Access Compliance Report Public Rights-of-Way (Curb Ramps)

Intersection ID: 51511 Main Street: PEARL_PARK_WY Cross Street: S_KINGS_DR Location: NE

ADA ID: 45DE779C96C9 Ramp Type: Perp Initial Pass/Fail: Fail Overall Compliance: No Severity Score: 12.5

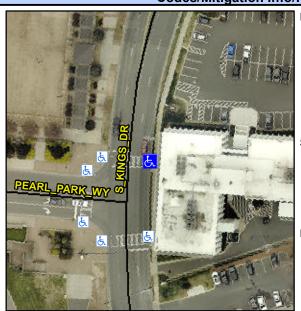
Comp	nance Description	Dala	Comp	mance Description	Data
N/A	Ramp Length (in)	85.0	No	Ramp Slope (%)	8.9
Yes	Ramp Width (in)	48.0	Yes	Ramp XSlope (%)	1.0
N/A	Flare Type LT	N/A	N/A	Flare Type RT	N/A
N/A	Flare Slope LT (%)	N/A	N/A	Flare Slope RT (%)	N/A
N/A	Flare Traversable LT?	N/A	N/A	Flare Traversable RT?	N/A
N/A	Landing Length (in)	N/A	N/A	DWS Provided?	N/A
N/A	Landing Width (in)	N/A	N/A	DWS Contrast?	N/A
N/A	Landing Slope (%)	N/A	N/A	DWS Length (in)	N/A
N/A	Landing X Slope (%)	N/A	N/A	DWS Full Width?	N/A
N/A	Landing Curb? (Y/N)	N/A	N/A	DWS Offset (in)	N/A
N/A	Shared Landing?	N/A			
N/A	Gutter Ponding?	N/A	N/A	Gutter Slope (%)	N/A
N/A	Gutter Lip Ht (in)	N/A	N/A	Gutter X Slope (%)	N/A
N/A	Painted X Walk1?	Yes	N/A	Painted X Walk2?	N/A
	X Walk 1 Direction	To W		X Walk 2 Direction	N/A
N/A	X Walk 1 Width (in)	120.0	N/A	X Walk 2 Width (in)	N/A
	X Walk 1 Slope (%)	5.5		X Walk 2 Slope (%)	N/A
	X Walk 1 X Slope (%)	1.7		X Walk 2 X Slope (%)	N/A

/Possible Solution		Field Me	
Possible Solutions:	Comp	liance Description	
Remove & Replace Entire Ramp.	N/A	Ramp Length (in)	
·	Yes	Ramp Width (in)	
	N/A	Flare Type LT	
	N/A	Flare Slope LT (%)	
	N/A	Flare Traversable L	
	N/A	Landing Length (in)	
Surveyor Notes:	N/A	Landing Width (in)	
N/A	N/A	Landing Slope (%)	
	N/A	Landing X Slope (%	
	N/A	Landing Curb? (Y/N	
	N/A	Shared Landing?	
PROW/ADA:	N/A	Gutter Ponding?	
Not Found, R304.2.2	N/A	Gutter Lip Ht (in)	
·	N/A	Painted X Walk1?	
		X Walk 1 Direction	
	N/A	X Walk 1 Width (in)	
		X Walk 1 Slope (%)	
		X Walk 1 X Slope (%	
	N/A	Ramp inside XWalk	
		Road Slope (%)
